CHANGE ORDER

PROJECT NAME: Edward A. Dufresne Community Center CHANGE ORDER NO: 001
 PPG OCD-DR PROJECT NUMBER: 45PARA3201
 CONTRACTOR: Lamar Contractors, Inc. CONTRACT DATE: 12-7-11

Subject: St. Charles Parish- Community Center
Gustav/Ike Project Number 45PARA3201
Review of Construction Change Order No. 1

SITE PLAN

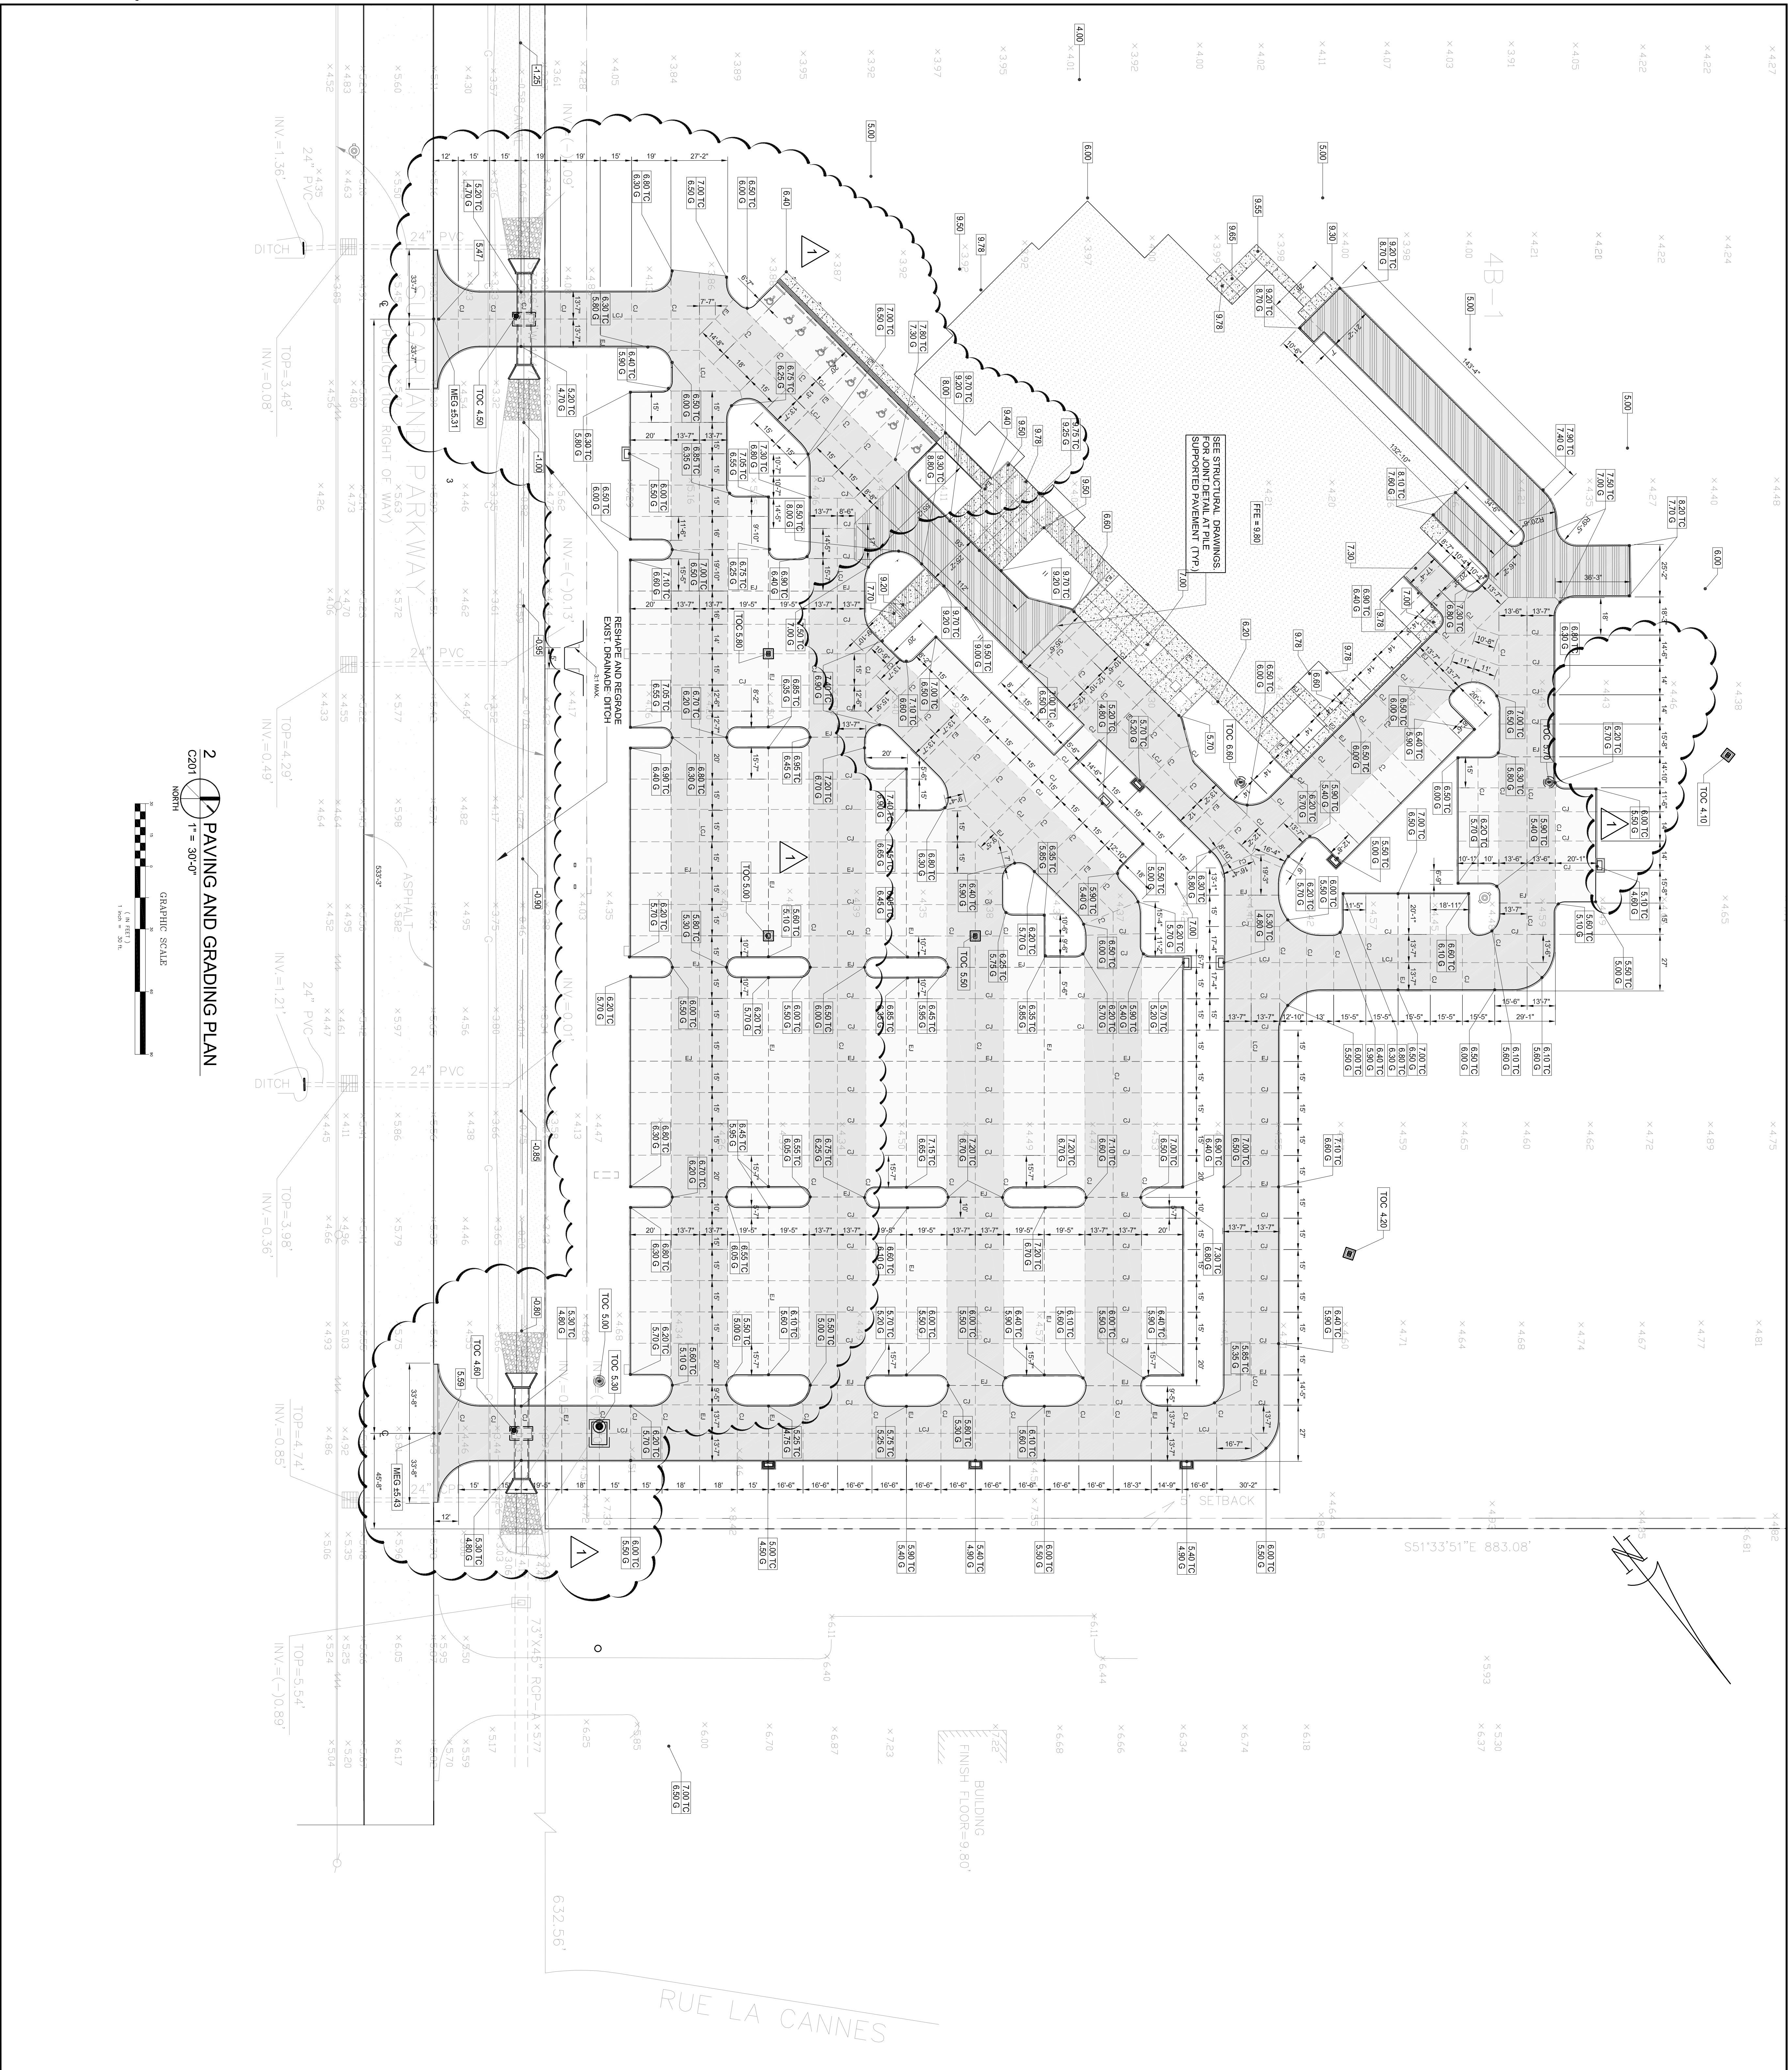
Per Owner's request, additional parking spaces and lanes to the parking lot configuration was issued as part of WCPR #005. RFC #10 rev 4 was submitted as a response to this WCPR.

Change Order Type	Quantity	Unit Price	Lump Sum Price
ADD- ADDITIONAL PARKING			
Change Order Description: APPROX ADDED 5' CURBS, W.W.F. FOR HEAVY DUTY CONCRETE AND W.W.F. FOR LIGHT DUTY CONCRETE FOR SITEWORK AND REVISED PILE SUPPORTED SLAS. LAYOUT AND DIMENSIONS AT FRONT ENTRANCE. REF: DRAWING C101 DATED 6/17/12	0.4 Tons		\$24,673.00

The revised parking plans as submitted in a August 16, 2012 email are approved with 'No Objection.'

NO.	REVISION	DATE
1	DRAIN LINE REVISION	8-21-2012
3		
4		
5

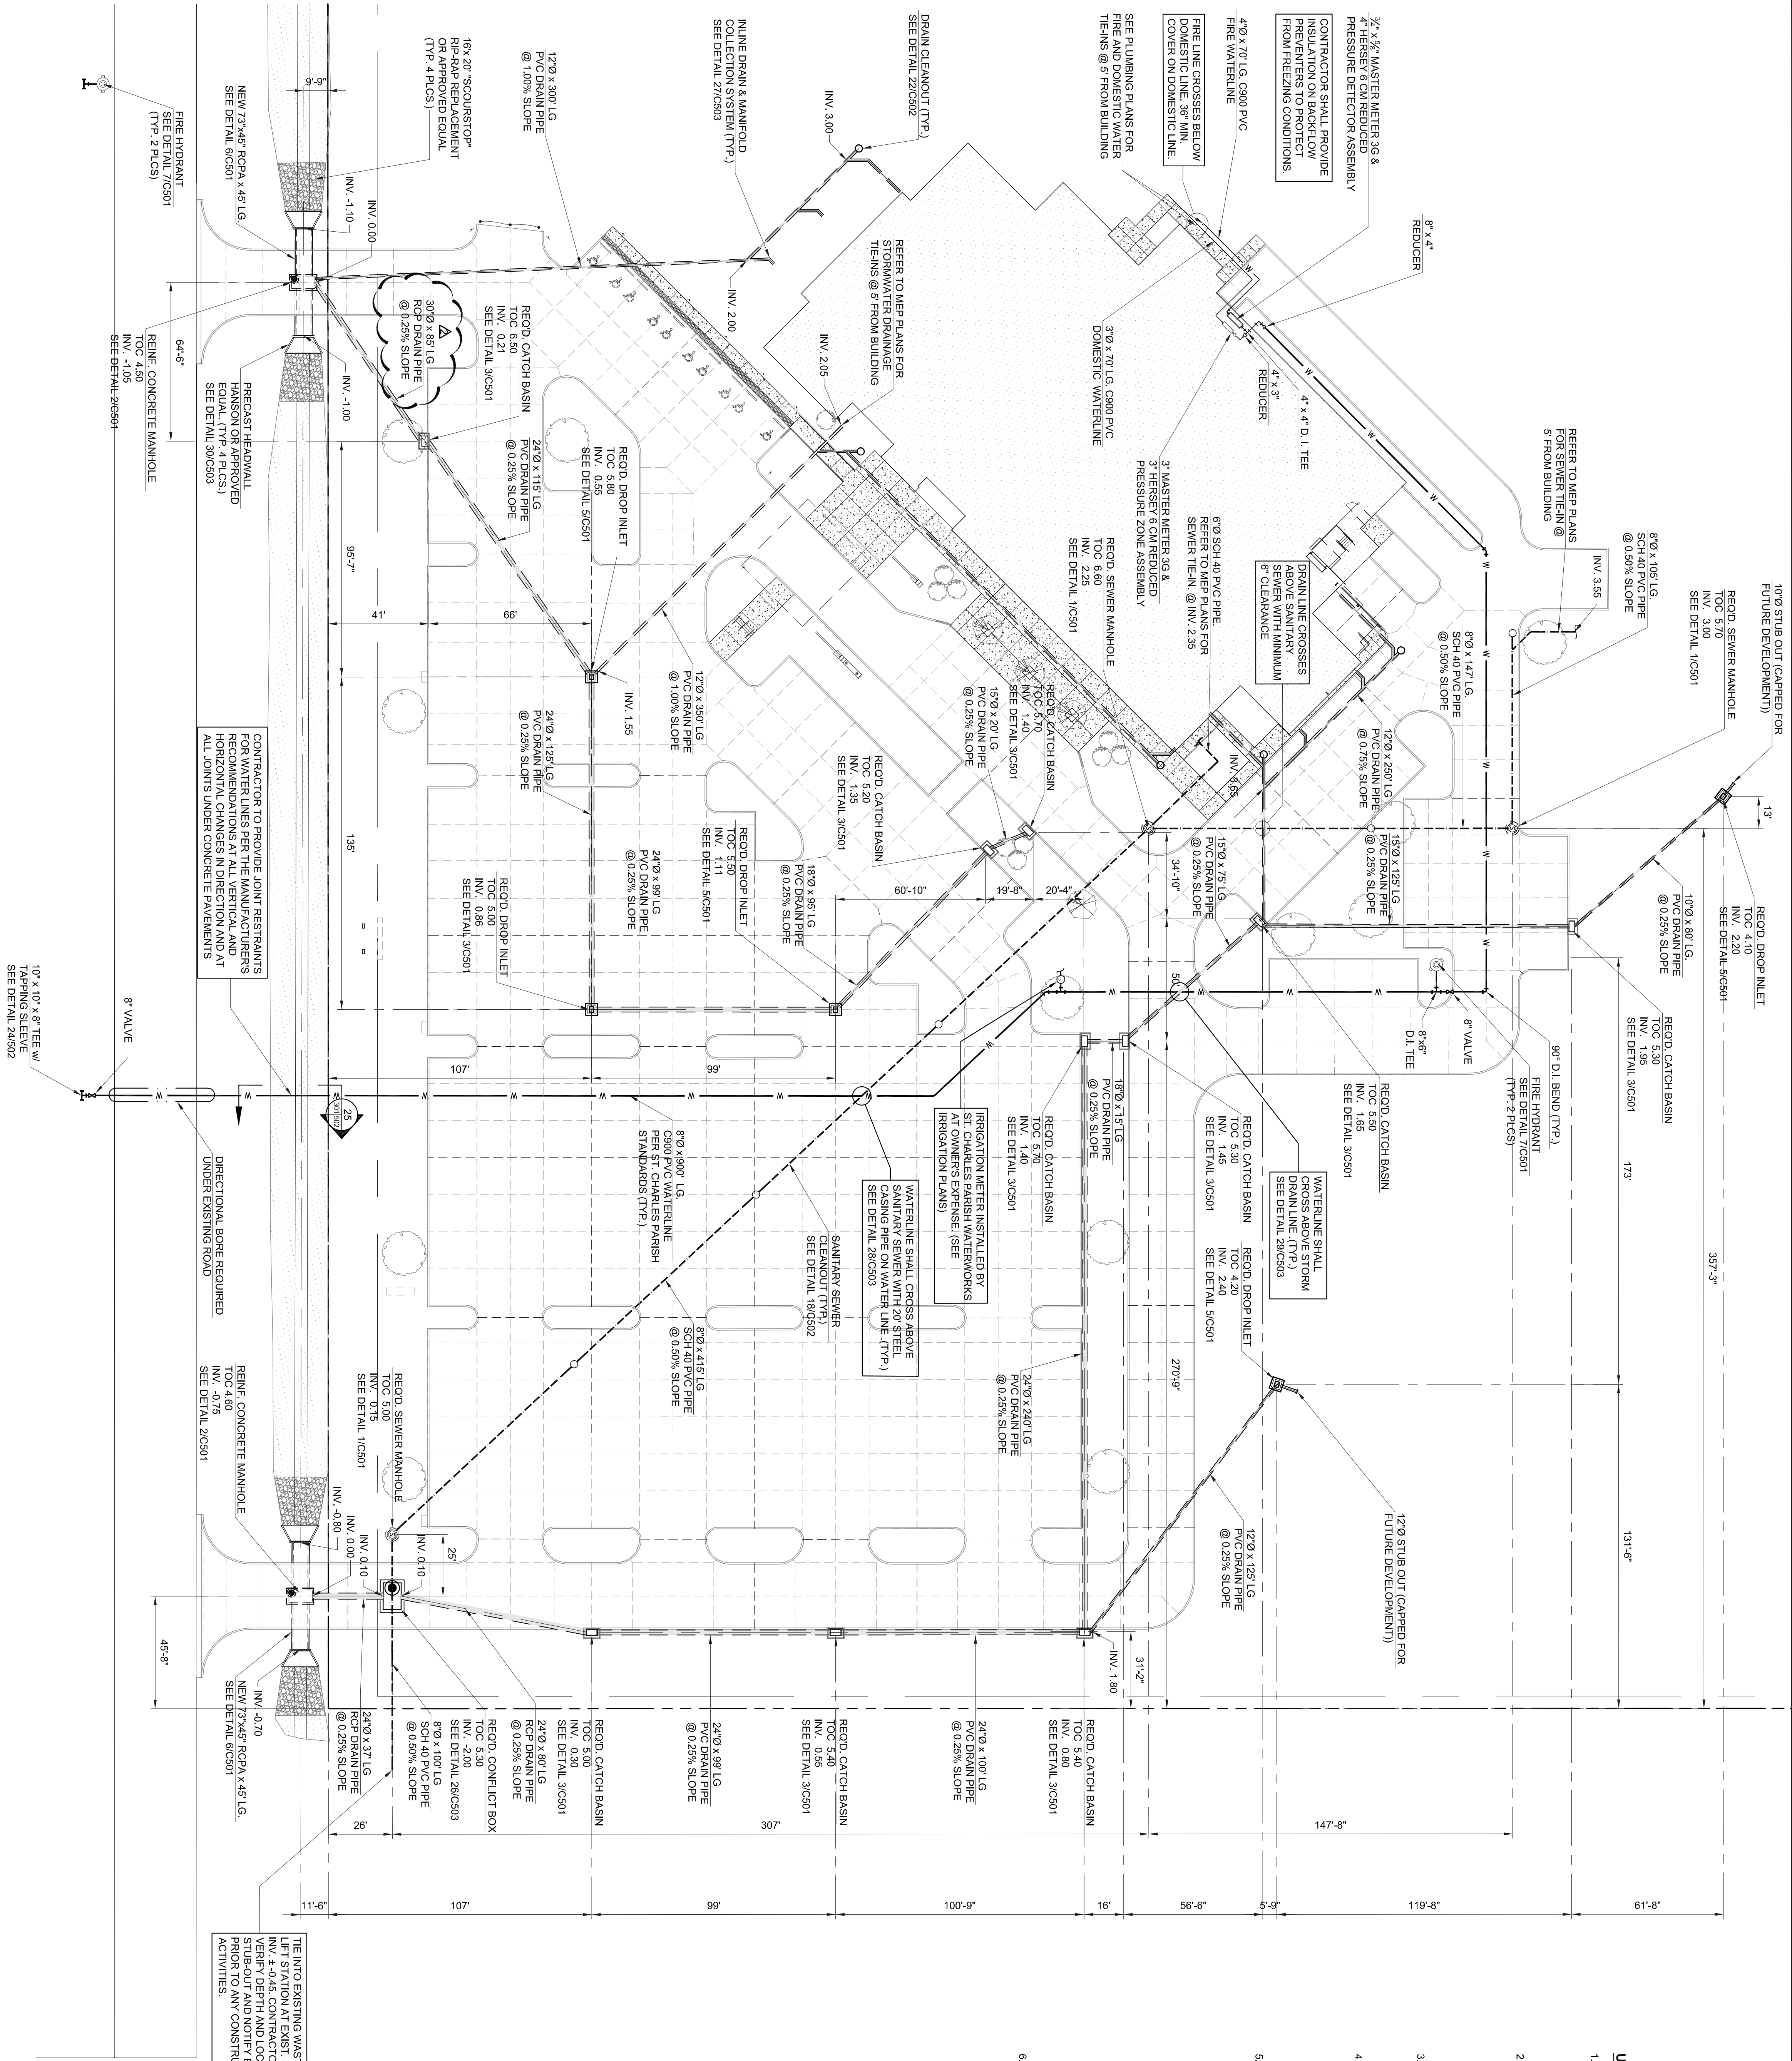
This change request is for furnishing additional labor and material required for storm drain modifications for WCPR-5 REVISED. Based on the revised C301 provided, install 88LF of 30" RCP in place of 24" PVC – the difference in labor and the cost of new material is applied. Relocate 1 catch basin. This change request is based specifically on the items detailed above. Additional changes on the plan appear in non-clouded areas associated with drop inlet elevations. These changes are not included as they are not in the change area and the material currently on site may work
